2007/2008 PROPOSED CHANGES TO THE INTERNATIONAL BUILDING CODE – MEANS OF EGRESS

MEANS OF EGRESS CODE COMMITTEE

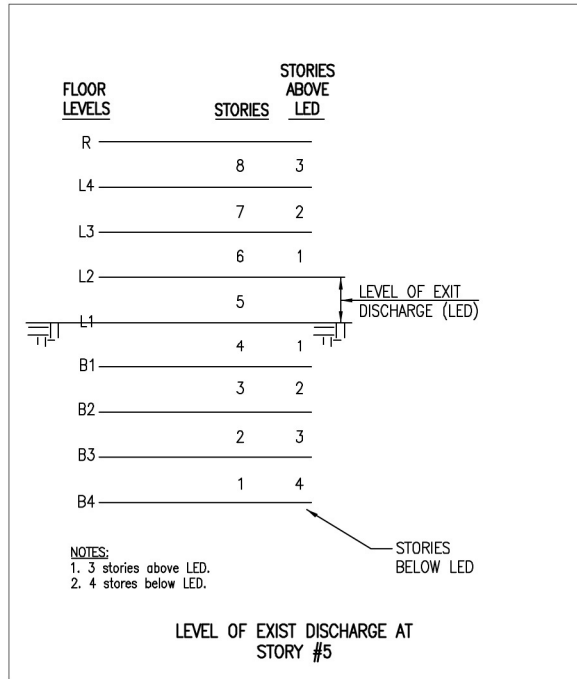
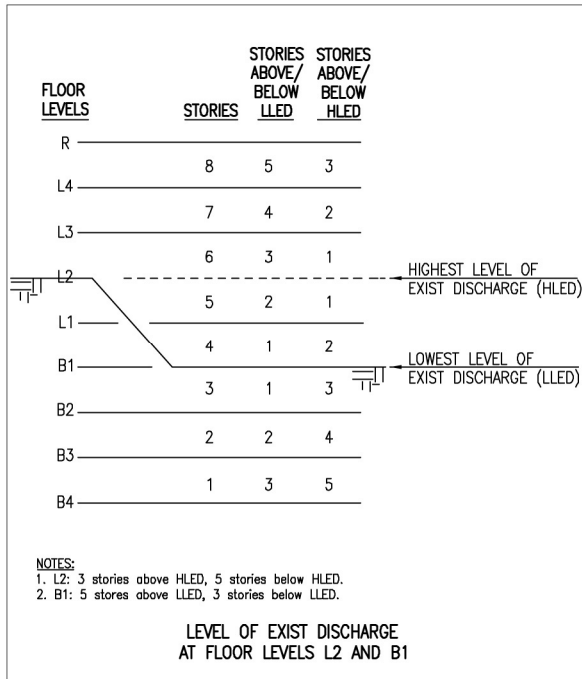
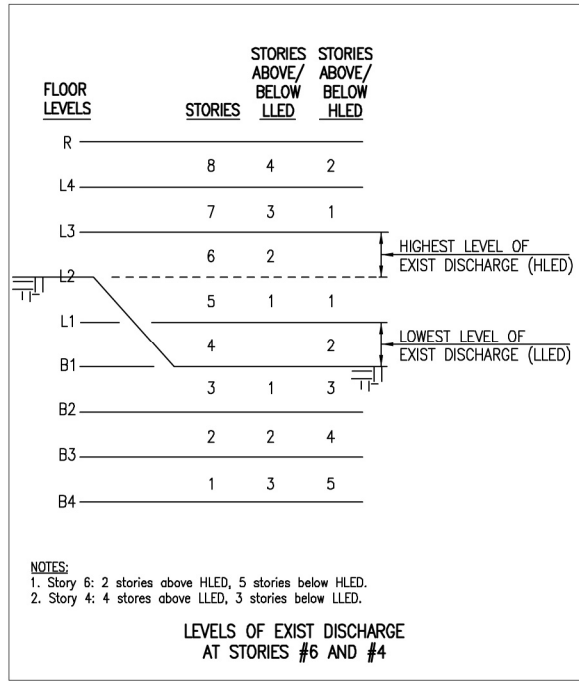
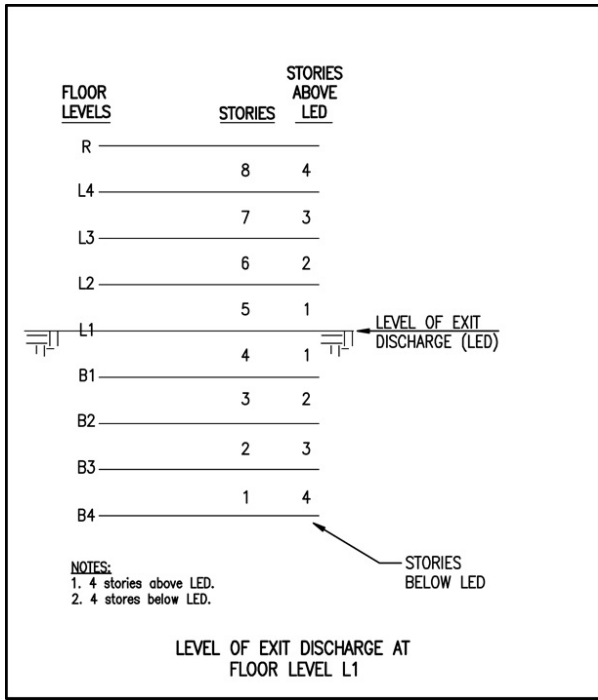
Four diagrams accompany this proposal. Each one illustrates a building with four stories above grade plane and four stories below grade plane, eight stories total. Floor Level L1 is at the same elevation as grade plane. Stories #1 through #4 are below grade plane and Stories #5 through #8 are above grade plane.

The first diagram ("Level of Exit Discharge at Floor Level L1") illustrates the application of the definition before being modified by Proposal E5-07/08. The level of exit discharge is at Level L1. There are four stories above and four stories below the level of exit discharge. The second diagram ("Level of Exit Discharge at Story #5") illustrates the application of the definition after being modified by Proposal E5-07/08. The level of exit discharge is at Story #5. There are now three stories above, but four stories below, the level of exit discharge.

The third and fourth diagrams illustrate the application of the definition when there are multiple levels of exit discharge. The third diagram ("Levels of Exit Discharge at Floor Levels L2 and B1") illustrates the application of the definition before being modified by Proposal E5-07/08. The upper and lower levels of exit discharge are at Levels L2 and B1, respectively. There are five stories above the lowest level of exit discharge and five stories below the highest level of exit discharge. The fourth diagram ("Levels of Exit Discharge at Stories #6 and #4") illustrates the application of the definition after being modified by Proposal E5-07/08. The upper and lower levels of exit discharge are at Stories #6 and #4, respectively. There are now four stories above the lowest level of exit discharge but five stories below the highest level of exit discharge.

The diagrams may accurately depict the intent of Proposal E5-07/08 but that proposal and the IFC interpretations noted in its reason statement also do not address how to apply the definition of level of exit discharge when determining a vertical distance of a horizontal plane above or below a level of exit discharge. There are 14 code sections in the IBC and 19 code sections in the IFC that specify requirements based on a level of exit discharge (33 total). Of these, only three in the IBC (Sections 1007.2.1, 1020.1 and 1023.6) and two in the IFC (Sections 907.2.9.1 and 1027.19) impose requirements based on the number of stories above or below a level of exit discharge.

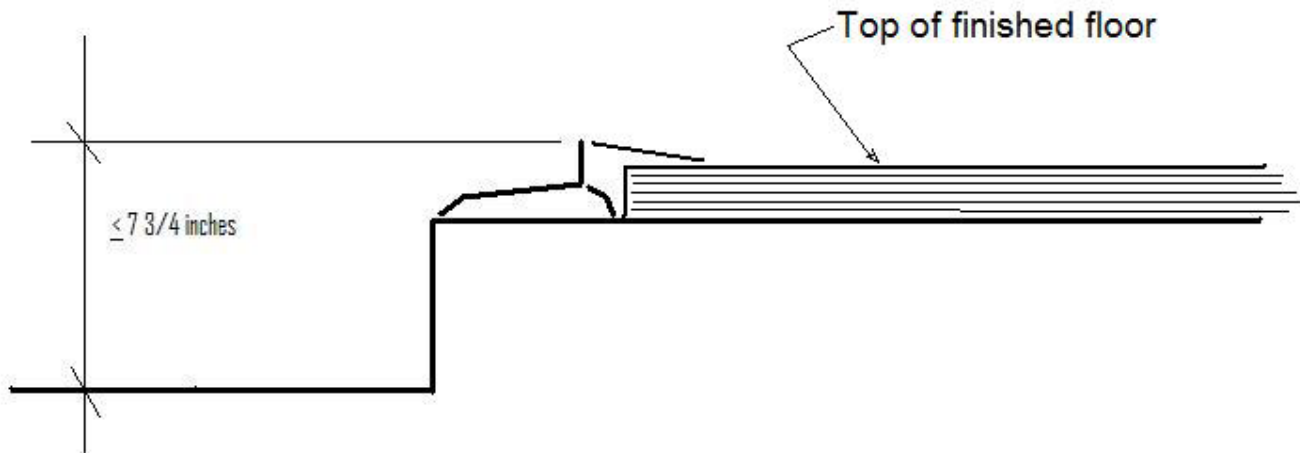
The intent of the two exceptions, however, is to permit a total height difference from the exterior floor surface to the top of the threshold of 7 ¾ inches, as stated in Exception 3 of Section 1008.1.4. In some cases that difference is provided by a difference in floor elevation between the interior and exterior spaces and therefore is addressed by the exception to Section 1008.1.4. In other cases, such as when the top of the interior and exterior floor are at similar heights, the barrier needs to be provided by the door threshold itself, and therefore the exception to Section 1008.1.6 is needed. Common instances when the top of the interior and exterior floor are at similar heights include when the exterior door is at grade, or when both the interior and exterior floor is provided by a concrete slab that is cantilevered through the exterior wall.

Case 1: Exterior step down occurs. Exception to Section 1008.1.6 permits the threshold to be greater than 1/2 inch or 3/4 inch in height, but exception 3 to Section 1008.1.4 limits the total distance in height (change in floor elevation + threshold height) to 7 3/4 inches.

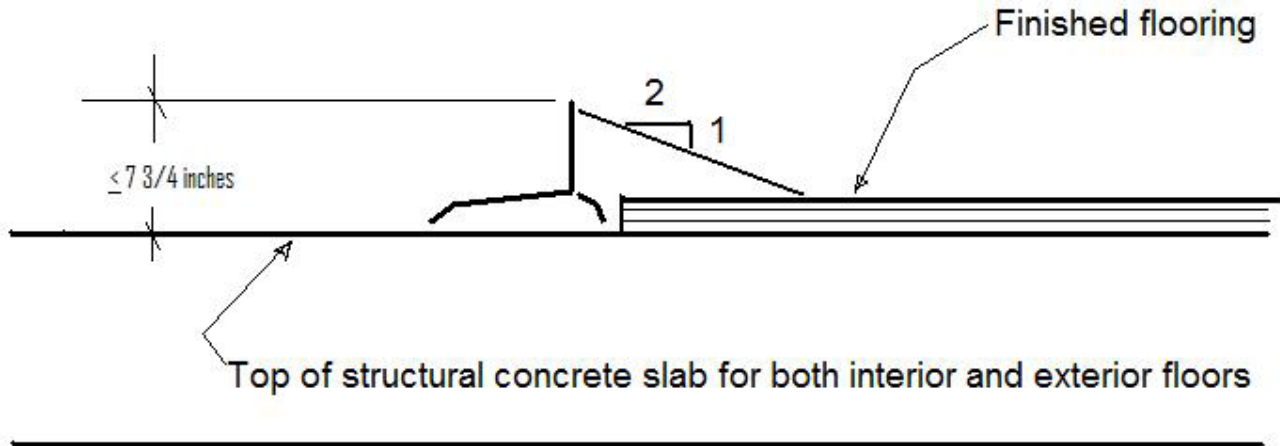
Case #2: Top of structural slab for both interior and exterior floor is at the same elevation. Only difference in floor height is from the interior finished flooring. Entire water barrier must be provided by the door threshold, which is permitted to be up to 7 3/4 inch in height by the exception to 1008.1.6.

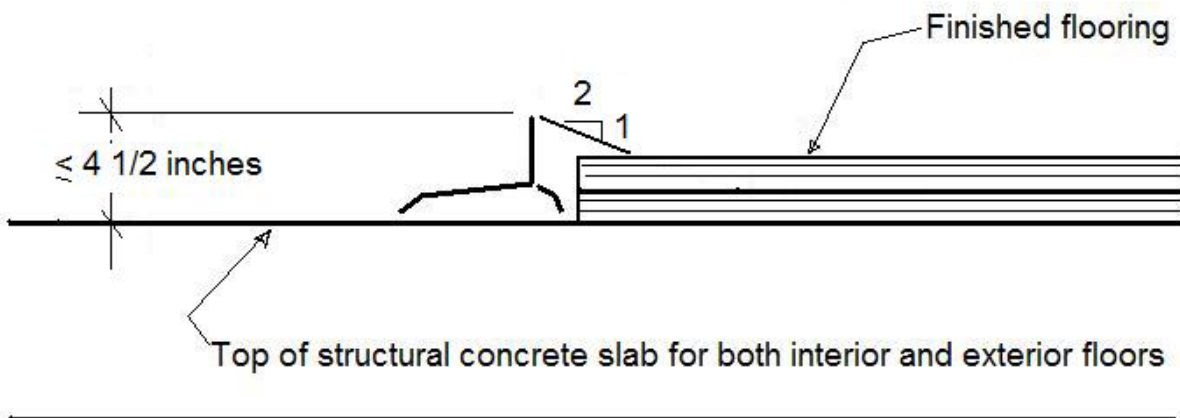
Case 3: Type B dwelling unit with same height structural floor both interior and exterior. Water barrier height is provided by a combination of threshold height and height of finished flooring, with total height limited to 4 1/2 inches.

IBC-2006 Section 1009.9.2
Code Proposal
Alternating Tread Device
Tread Dimensions

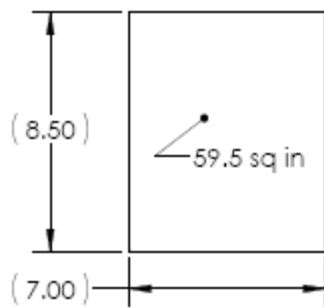
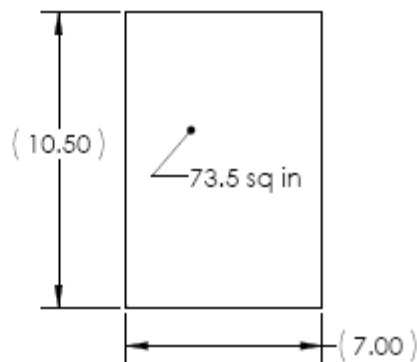
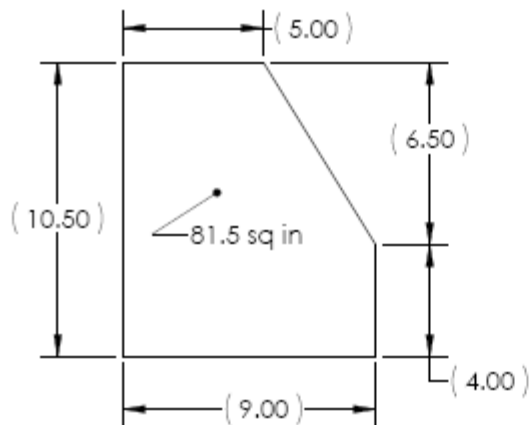
The current requirements for tread dimensions of alternating tread devices were originally incorporated into BOCA via Code Change B98-85, section 816.12.2 (at the same time alternating tread devices were first added to the code). The required dimensions for alternating tread devices have not changed since the original proposal (The current wording in IBC-2006 is nearly identical to the wording in B98-85). Mark Rollman representing Lapeyre Stair was the submitter of code change proposal B98-85. Lapeyre Stair is the original patent holder (1980) of the alternating tread device and for many years was the sole manufacturer of alternating tread devices (non-residential). A reasonable assumption is that the original proposed dimensions for the treads of alternating tread devices were based on the Lapeyre Stair tread design (which has not changed since Lapeyre Stair began manufacturing alternating tread devices). However, as explained below, there are possible interpretations of the code, such that this tread design does not meet the code requirements.

The code requires a minimum tread depth of 8.5 inches (10.5 inches for mezzanines) and a minimum tread width of 7 inches. These are shown in illustrations 1 and 2 which assume a rectangular tread. The model tread upon which the code is based has a tread depth of 10.5 inches and a tread width of 9 inches at the nosing side and 5 inches at the opposite side of the nosing. This is shown in illustration 3. Although approximately 37% larger in area, this model tread does not meet an interpretation which assumes a rectangular tread shape; as the 5 inch tread width at the side opposite of the nosing is less than 7 inches. The proposed change allows tread shapes other than rectangular, which the model tread meets, while ensuring adequate foot landing area by specifying a required area of the tread.

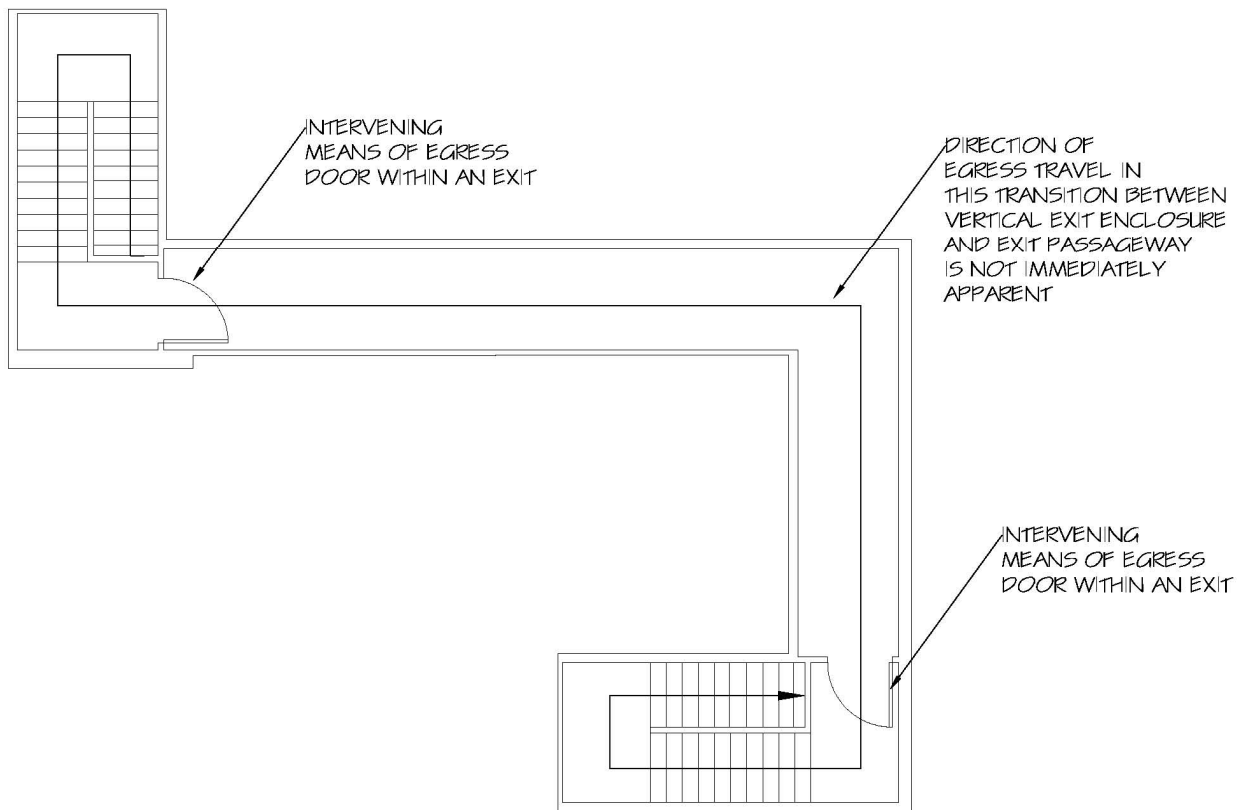
Reason: Section 1011.1 requires exit signs along the exit access to help occupants to reach the exits. Typically, once the occupants reach the exits, exit signs are not required within the exits. However, in buildings with more complicated egress layout, it is possible that the direction of egress travel within the exits may not be immediately apparent to the occupants. For example, a vertical exit enclosure on the north side of a building may transition into a horizontal extension in the form of either an extended landing/corridor or an exit passageway with intervening means of egress doors on the 15th floor before continuing down into the staircase on the south side. The path of egress might involve turns with extended distances. In such cases, it is important to provide clear egress direction for the occupants within the exits.

The report from the 2003 World Trade Center Building Code Task Force identified the problem of clarity or “readability” of travel within exit enclosures, and in response to the 1993 and 2001 World Trade Center incidents, recommended additional exit signs within the exit enclosures.

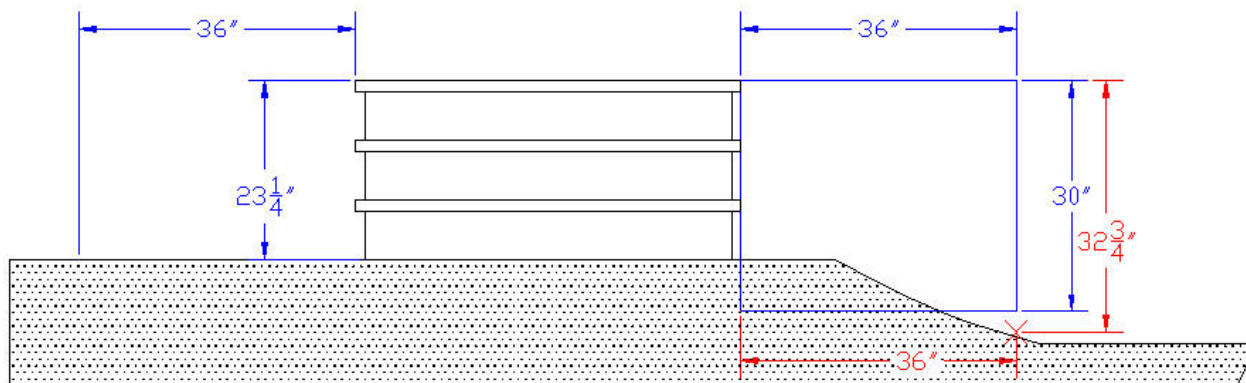
The diagram below was drawn by the author and is shown as a visual guide or technical drawing. The drawing shows a 3 riser front entry stoop with 7-3/4" risers from a front elevation. The ground is detailed in outlined dots. The 36" horizontal with 30" vertical box on the right shows the area in which the code change submits the measurements should be taken. The 32-3/4" vertical point shows the deepest point within the 36" horizontal edge measurement. The left side of the stoop is shown not over 30" in height and thus no guard required.

Thus if this stoop was on a facility it would require a guard be installed on the right side only as the left side is not 30 inches or more deep.
